**RE: Trails at Crowfoot Filing No. 16 – Final Plat
Review Comments 02**

**TOWN OF PARKER DEVELOPMENT PLANNING DIVISION, Stacey Nerger, Senior Planner,
Review Comments 02**

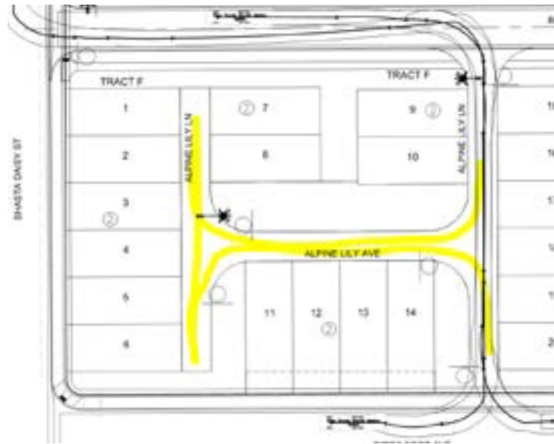
6. Comment: The applicant shall provide an auto turn analysis indicating that apparatus can navigate all portions of this site); NO PARKING – FIRE LANE signage is required for any portion of the access where the 20-foot clear width requirement cannot be met. Information on South Metro Fire Rescue Apparatus has been provided later on in this response. Address when resubmitting. *Partially satisfied; applicant has provided an auto turn for only a portion of the site while not providing the analysis for Alpine Lily Ave and Alpine Lily Ln. A resubmittal is required to show that these areas comply as this is the central portion of the project. See below for highlight area that must be addressed.*

Response: Revised Autoturn and signage has been provided and included with this submittal.

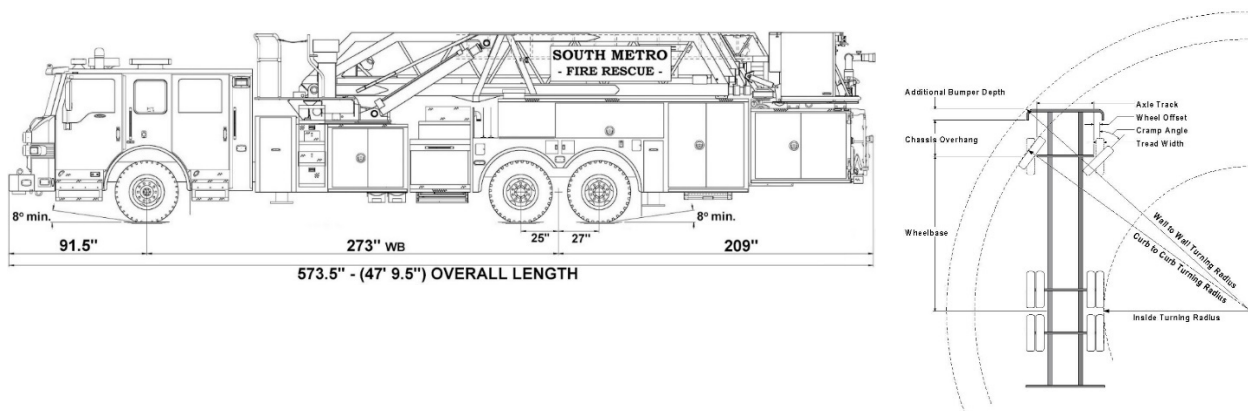
Comment: The minimum unobstructed width of the fire apparatus access road shall be 20 feet. In order to maintain the minimum width and prevent obstructions such as parking of vehicles fire lane signs shall be installed in an approved manner. A minimum vertical clearance of 13 feet, 6 inches shall be maintained for the entire required width of the access road.

Response: Acknowledged, this site meets this requirement.
